SUBDIVISION REVIEW SHEET

CASE NO.: C8J-2022-0177

SUBDIVISION NAME: Easton Park Section 4B East Preliminary Plan

CITY OF AUSTIN – TRAVIS COUNTY – SINGLE SUBDIVISION OFFICE
SUBDIVISION APPLICATION – MASTER COMMENT REPORT

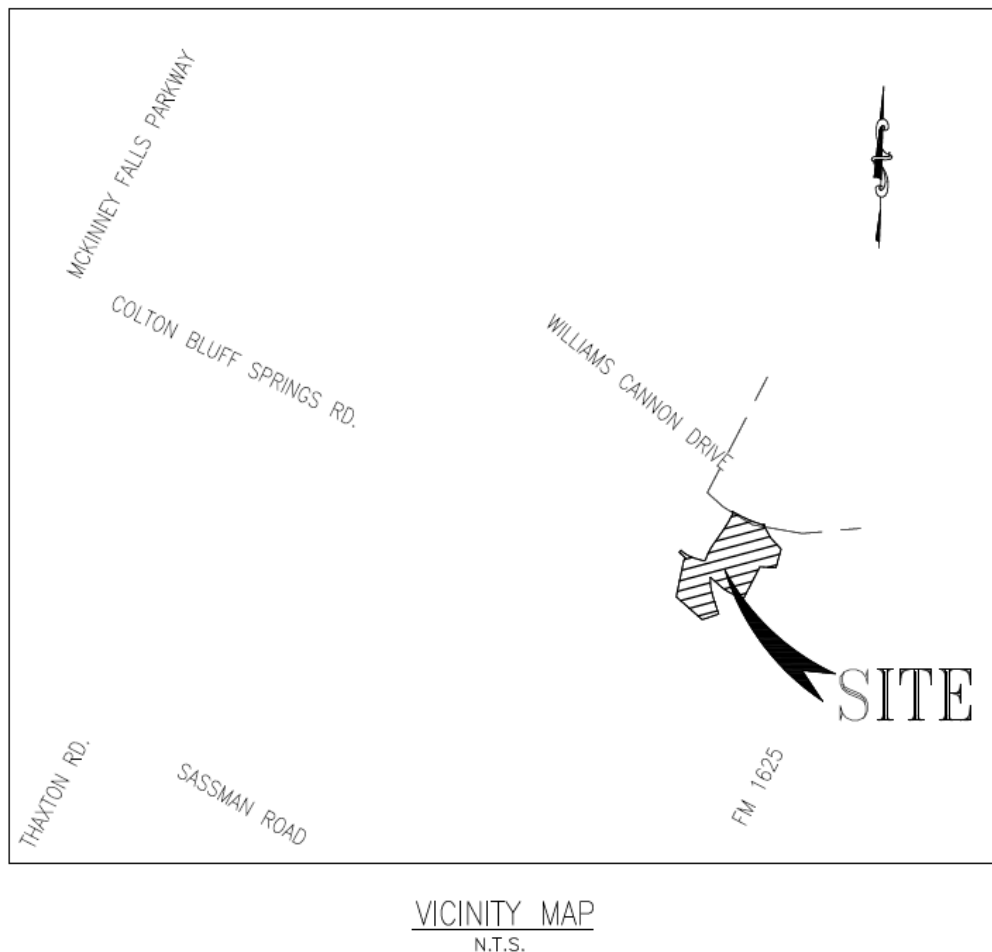
AD2: Please remove the punctuation marks from the following:

1. **COLTON BLUFF SPRINGS RD** in the vicinity map
2. **THAXTON RD** in the vicinity map

AD3: Please label streets in the ROW. The vicinity map does not show where the ROW segments are, only the labels

PRELIMINARY PLAT COVER SHEET

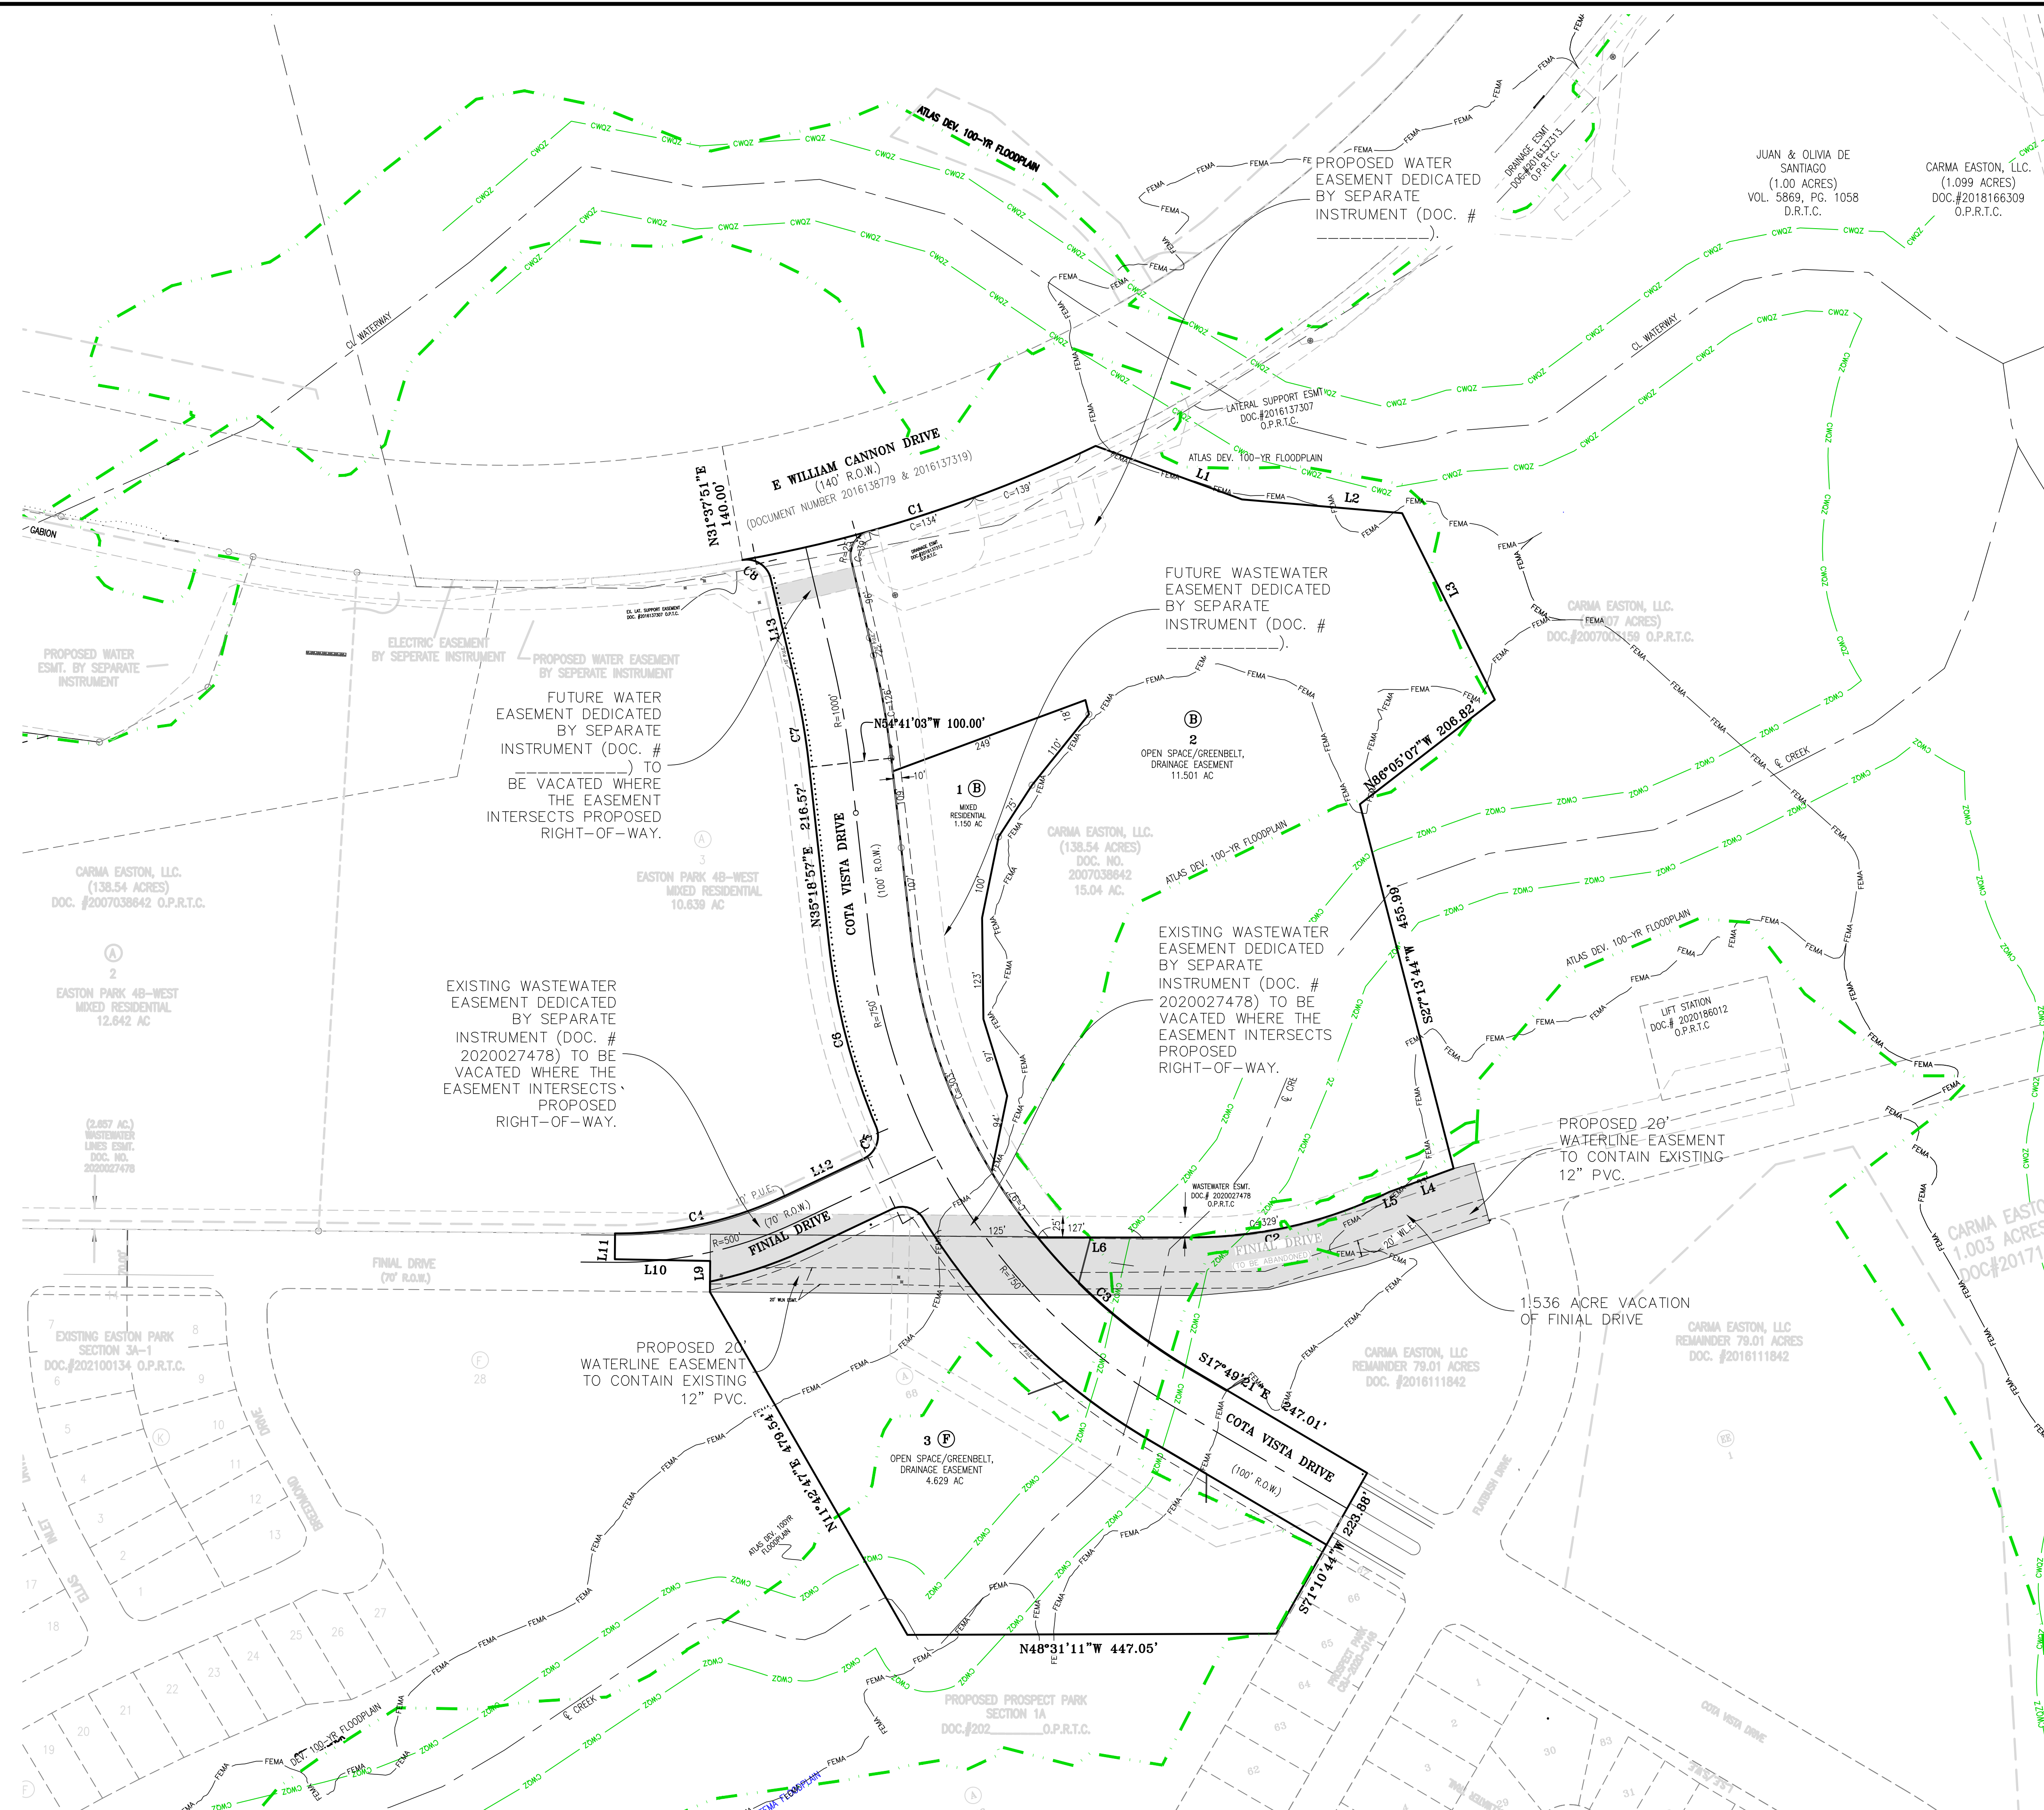
PR 1: Please clarify if lot 2, block B is intended to be part of the greenbelt. If it part of the system please amend the label to 'open space/greenbelt park' and amend note 10 on to the plans:

PR 3: Please amend the label on Lot 3 F to read 'open space/ greenbelt park'.

PR 4: Define the boundaries of the drainage easement and water quality easement on the greenbelt park/open space blocks. Defining the easements areas is required so that park areas are not at risk of being lost by "blanket" easements. Also credited park acres needs to be determined to include Lot 2 Block B

PR5: Provide a table on sheet 2 similar to previous preliminary plans (this table shows credited park acres). Be sure to include the 11+ acres from Lot 2, Block B
